CITY OF TACOMA Public Works Engineering Division

ADDENDUM NO. 6

REVISIONS TO: Request for Bids Specification No. PW23-0021F Links to Opportunity Streetscape – Bid Package 3

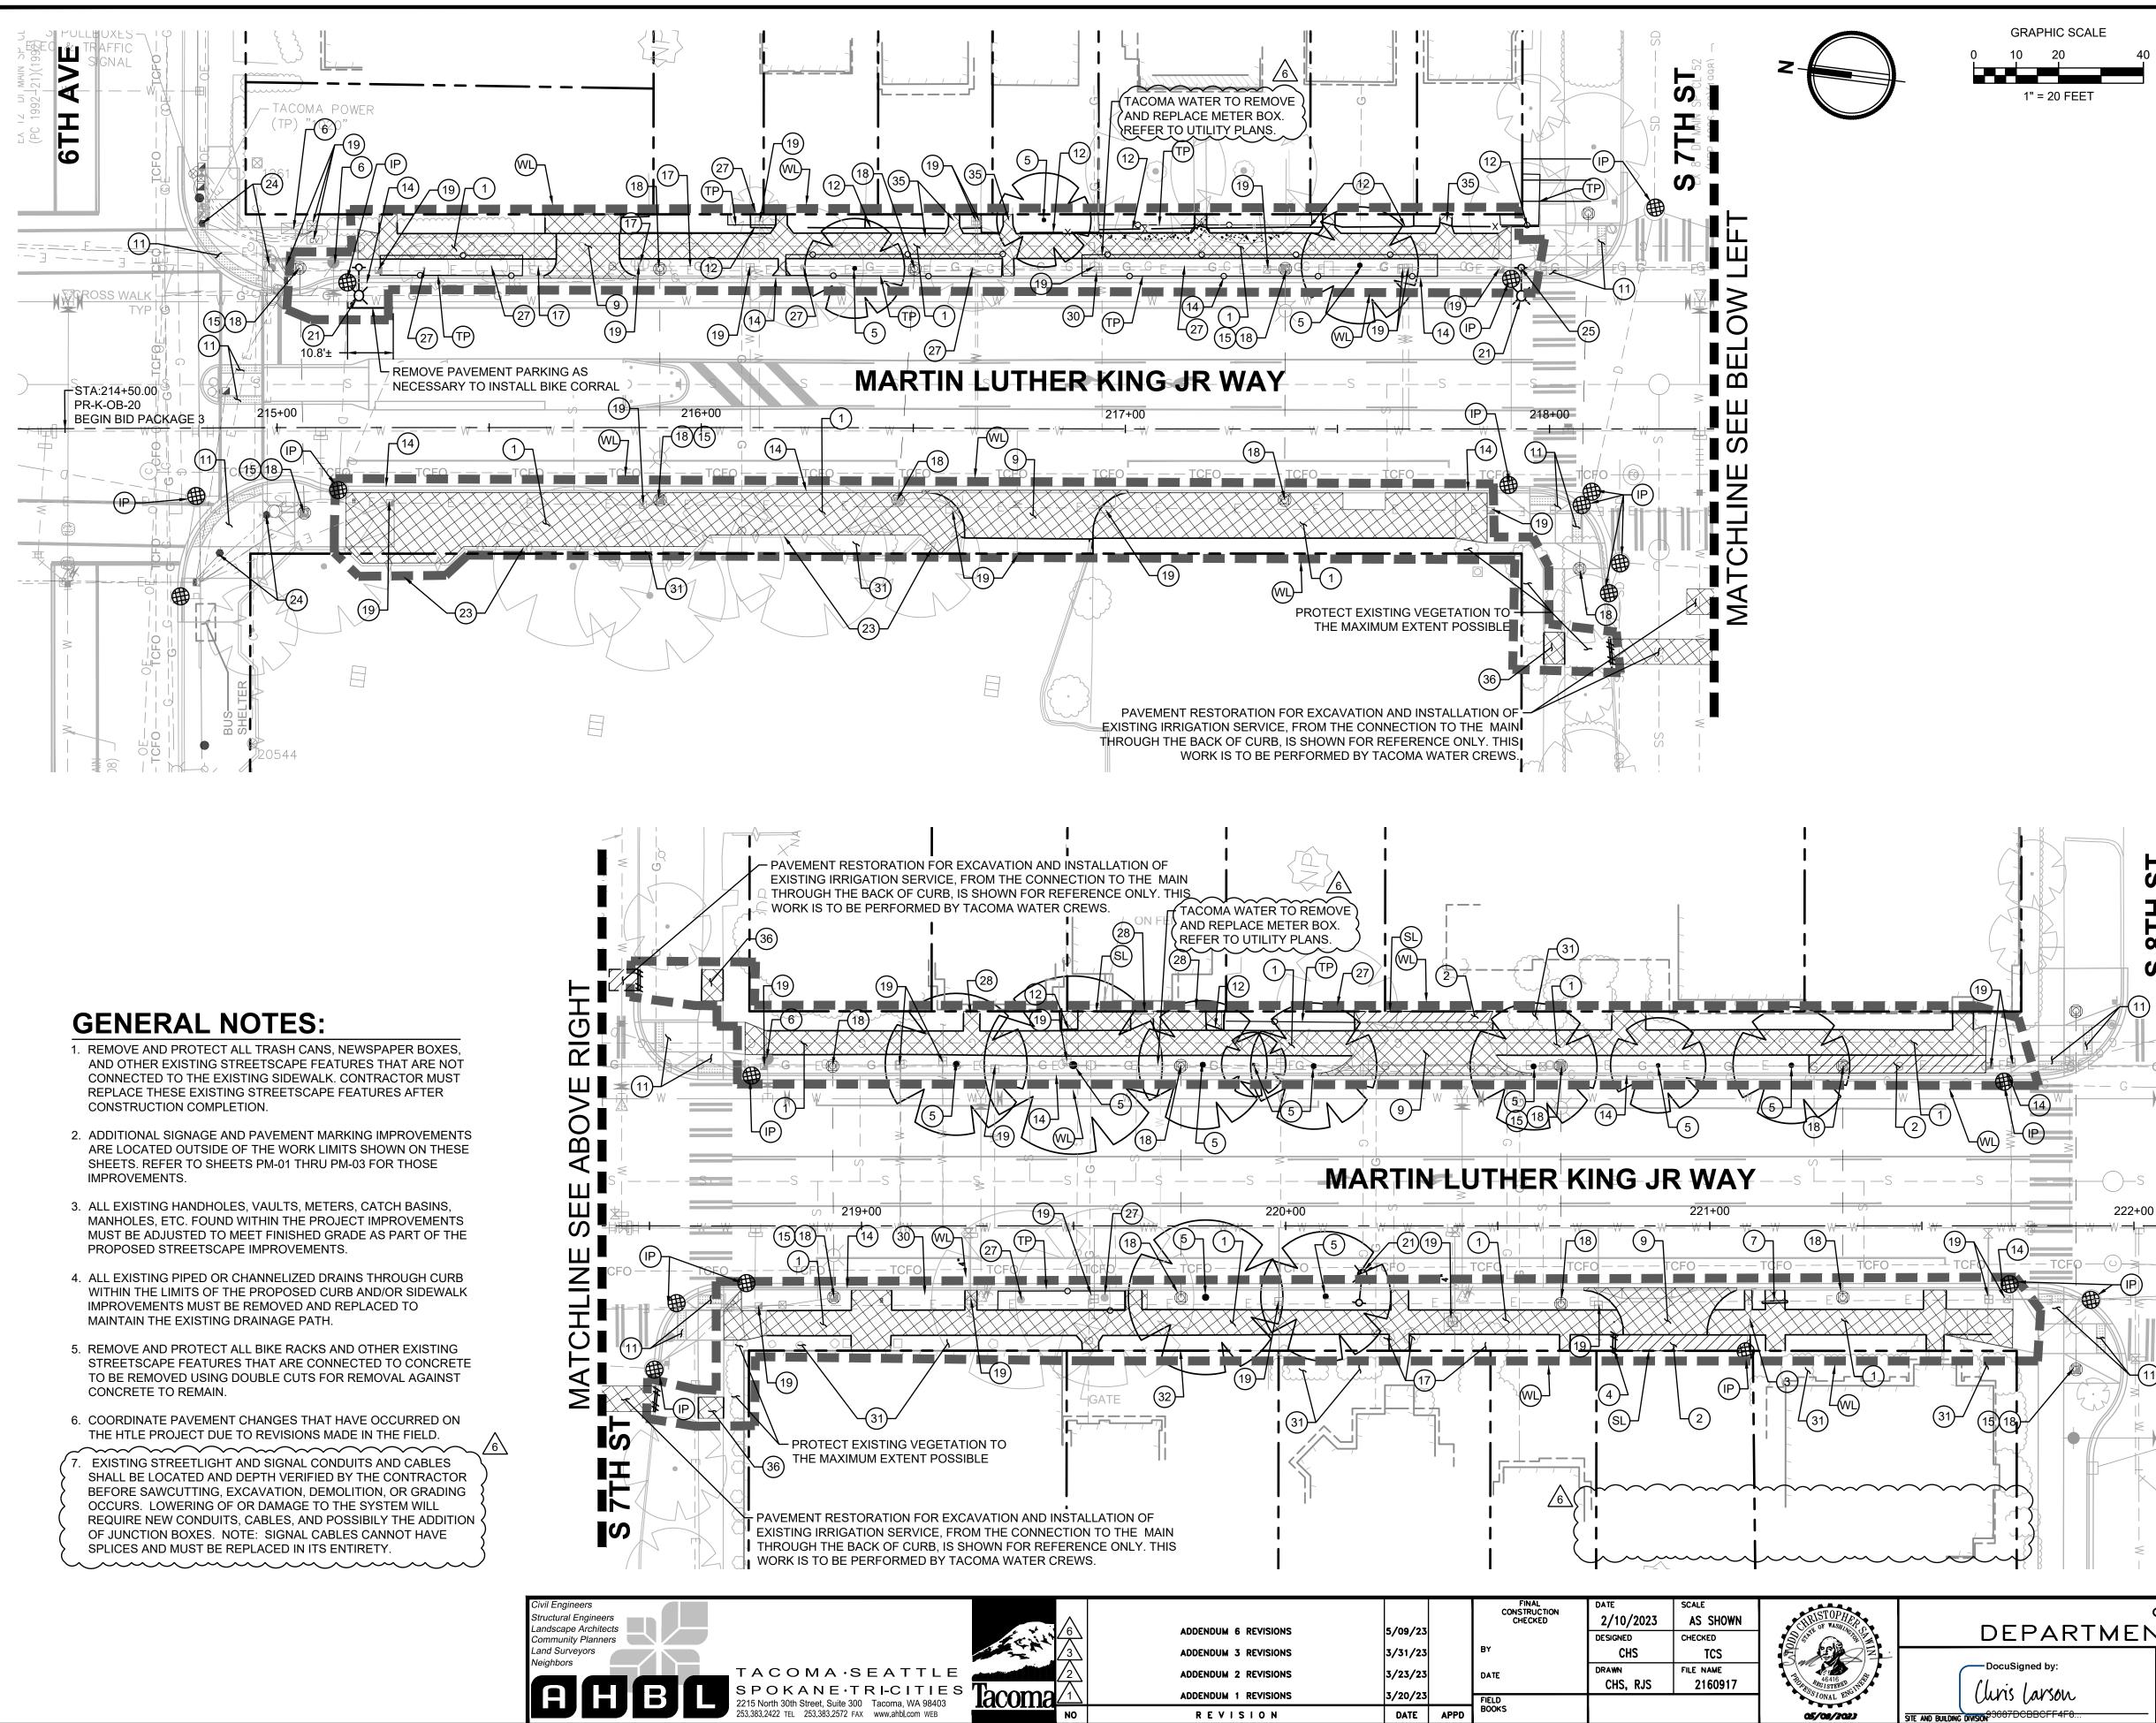
Replace Plan sheet MC-01. Quantity of bid item R-69 Service Connection to Tacoma Power is changed from 12 to 9.

SHEET NO. EC-01

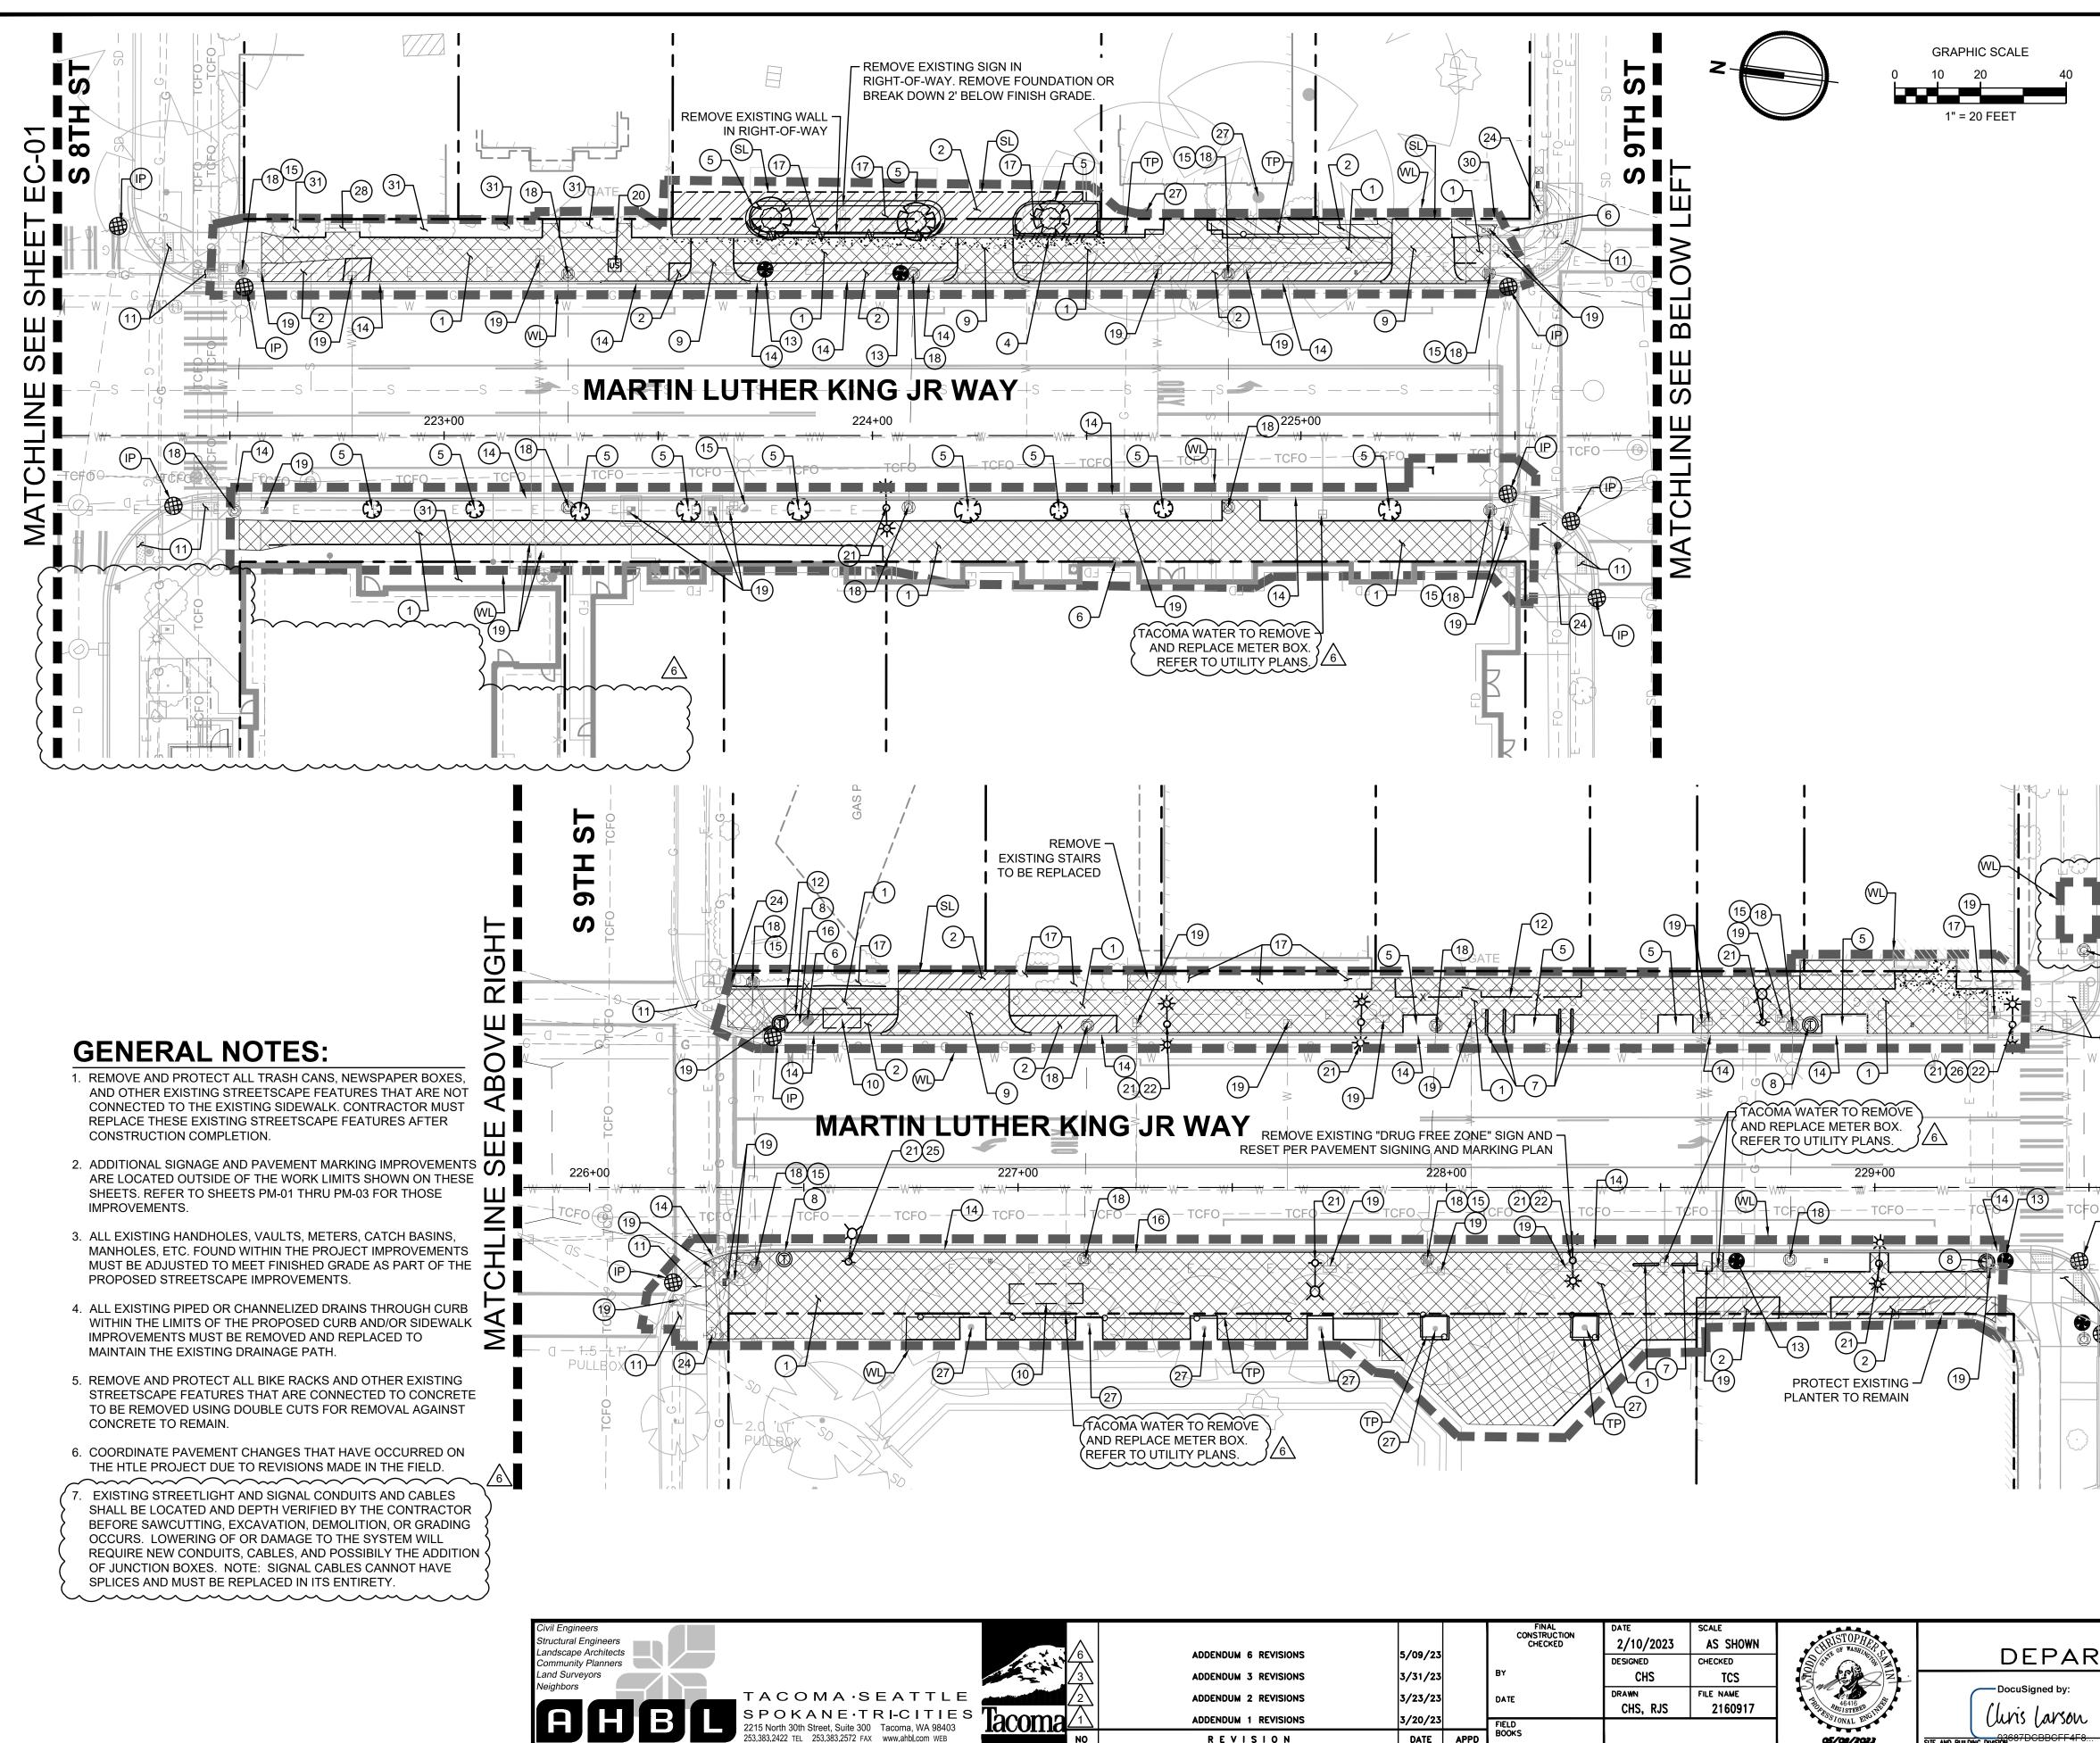
Replace Plan sheet EC-01. Updated notes and revised plan background.

SHEET NO. EC-02 SHEET 4 OF 58

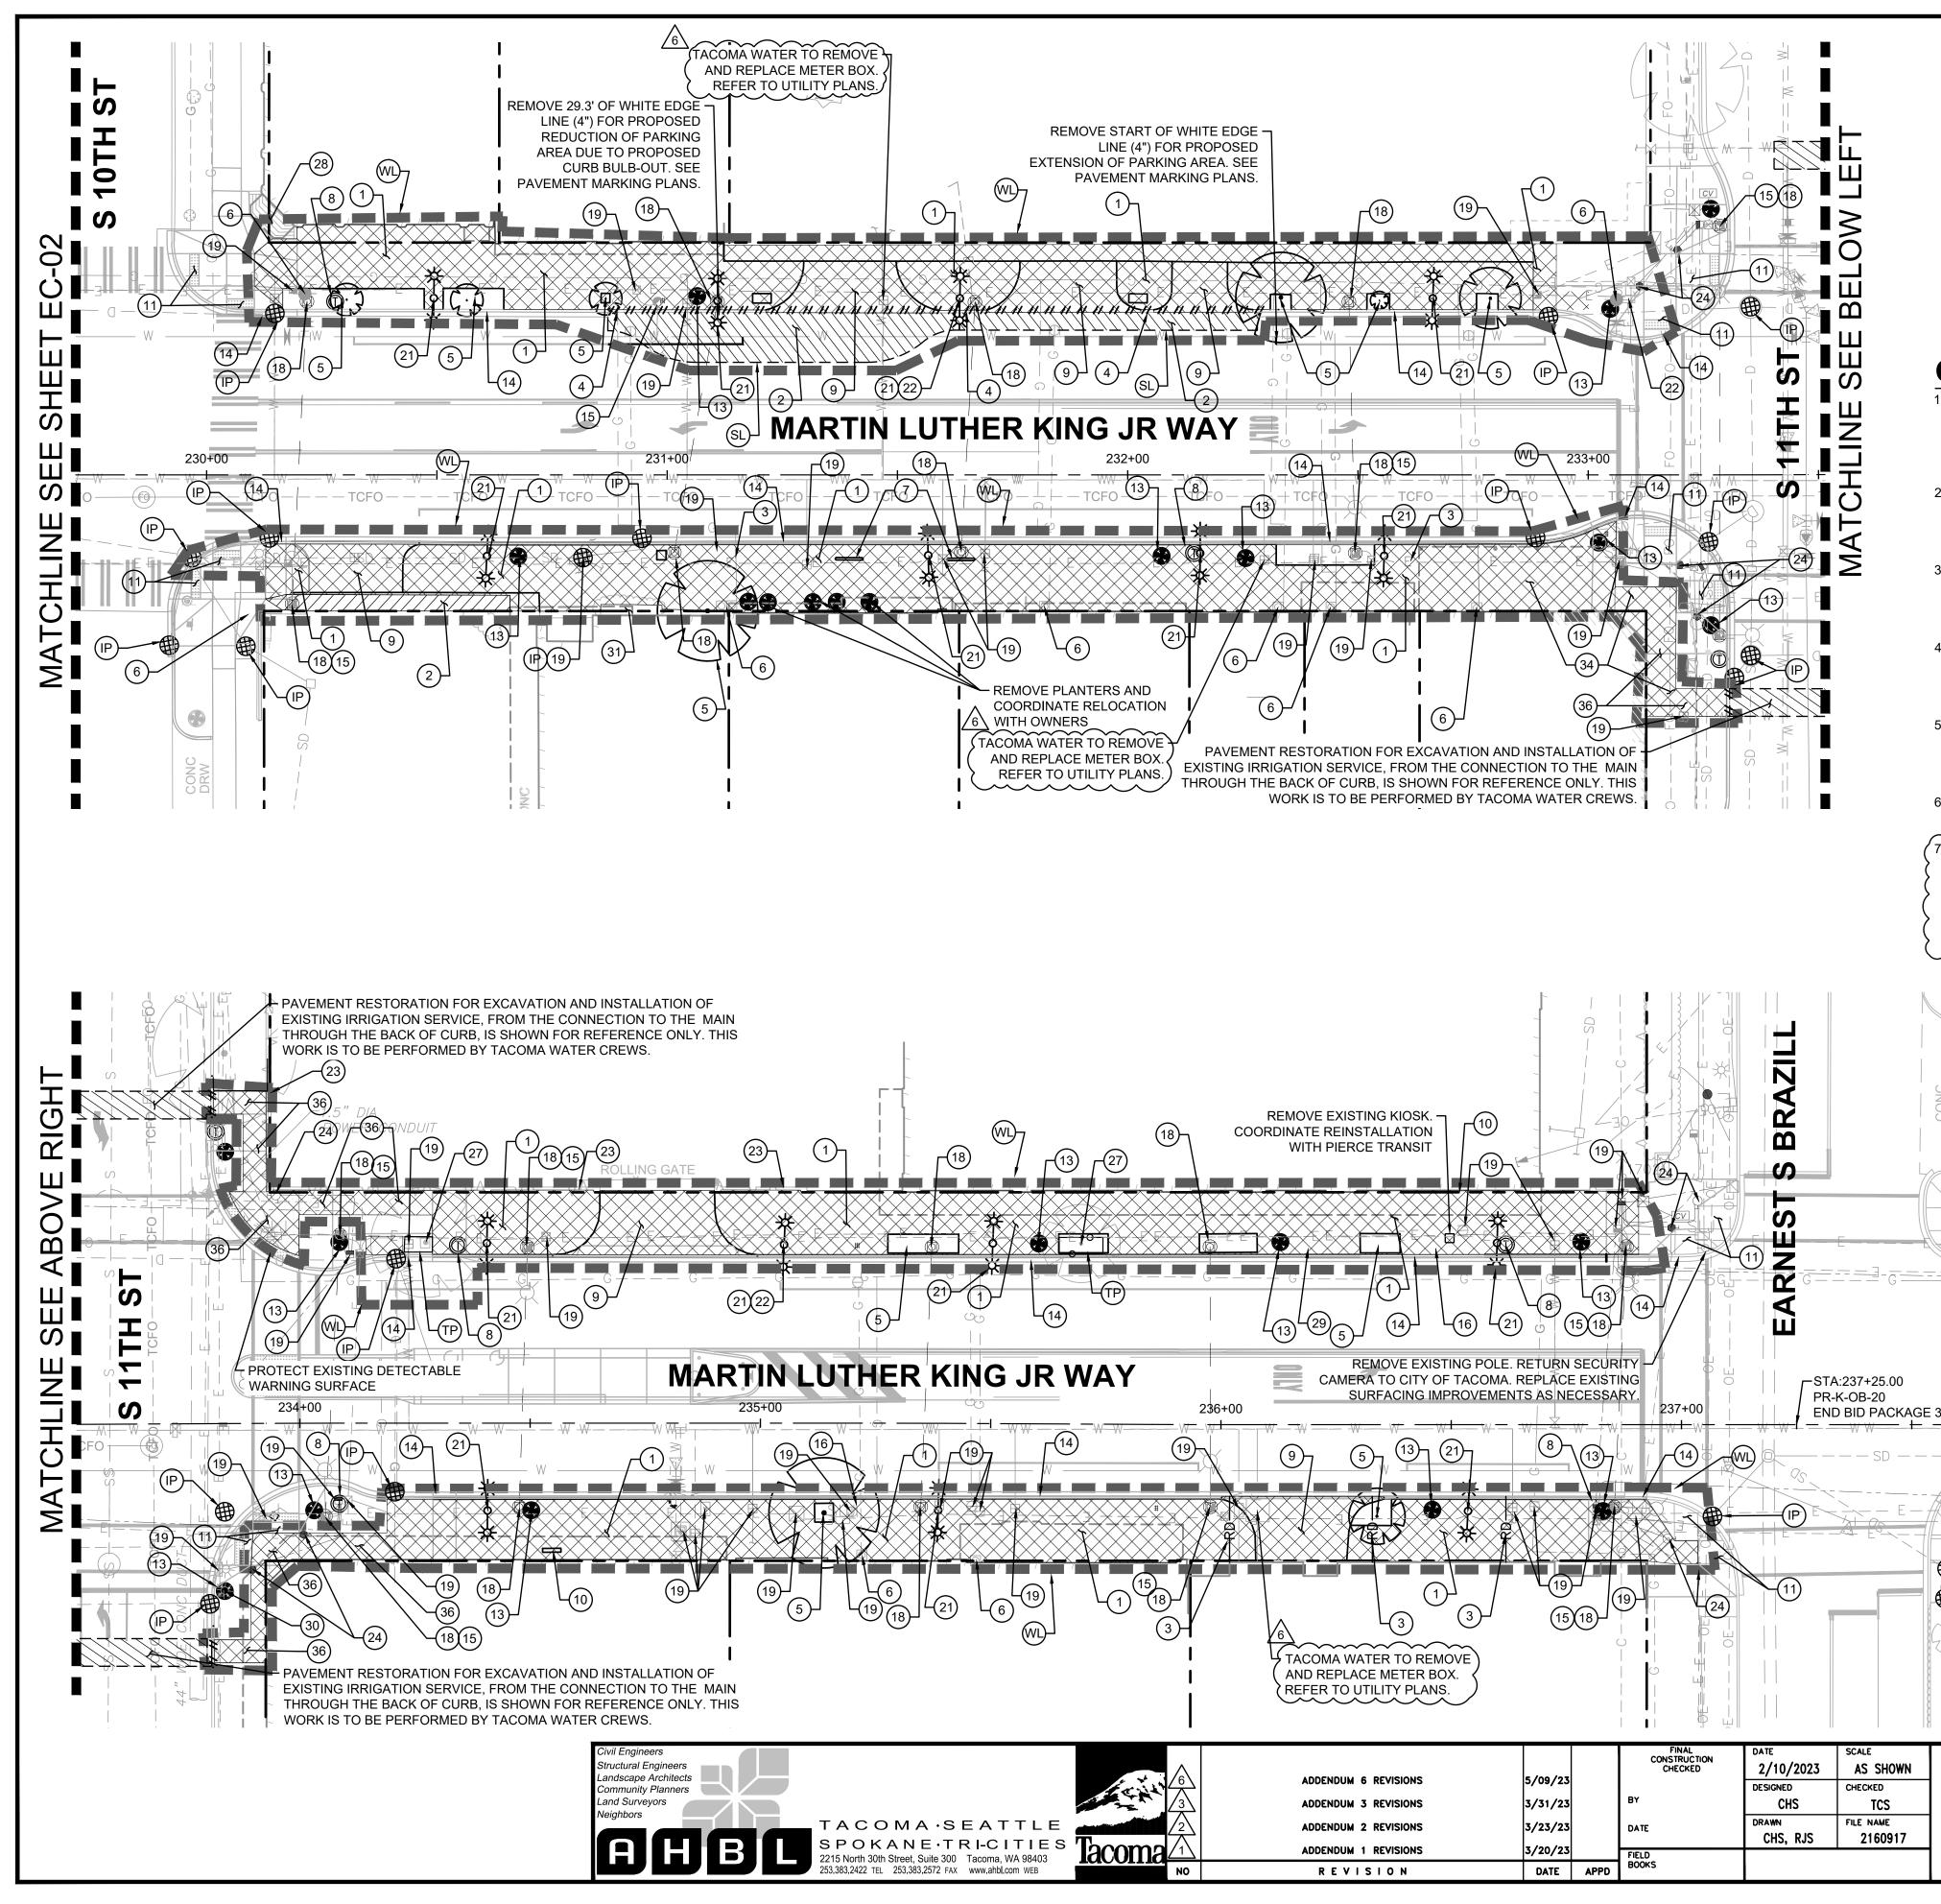
Replace Plan sheet EC-02. Updated notes and revised plan background.
